To all members of MECHATROLINK Members Association

**About the version upgrade of
MECHATROLINK-III C1 master Access Driver (version 1.22)**

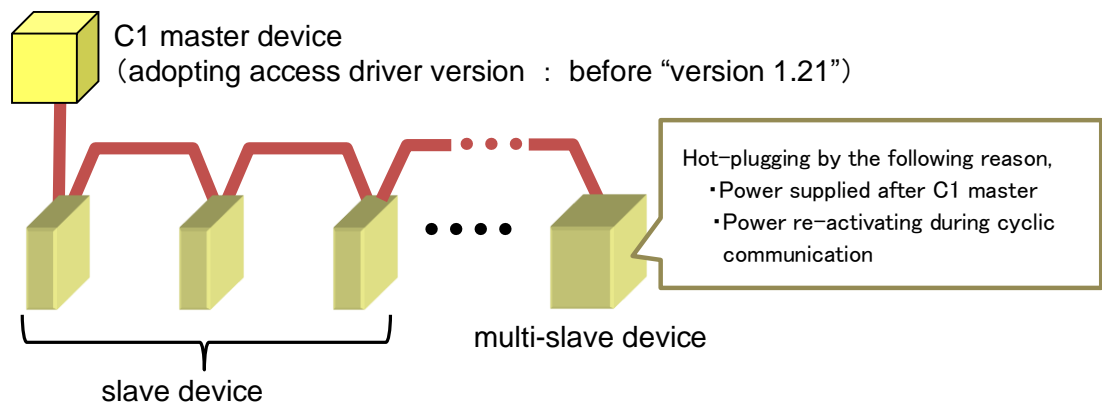
In the MECHATROLINK-III system that connects a multi-slave device like as figure1, if the power supply timing of multi-slave device was delayed from C1 master power supply timing, then C1 master device is shifted to cyclic communication state first before the multi-slave device. Therefore C1 master device performs the hot-plug procedure to multi-slave device.

Then, there is a possibility that a problem occurs (described in “2.2 The problem which can occur”) and can't start cyclic communication normally between C1 master device and multi-slave device.

There is a possibility that the communication delay measurement to multi-slave device can't normally complete, and cyclic communication isn't begun between the C1 master device and multi-slave device.

When the problem mentioned to "2.2 The problem which can occur" occurred, it's possible to restore MECHATROLINK-III cyclic communication by doing one of the following. (A or B)

- A. Power supply re-activating of C1 master device.
- B. After power off of the MECHATROLINK-III system (all devices), and supplying power in the following sequence.
 1. Supplying power to the slave devices.
 2. Supplying power to the master device.
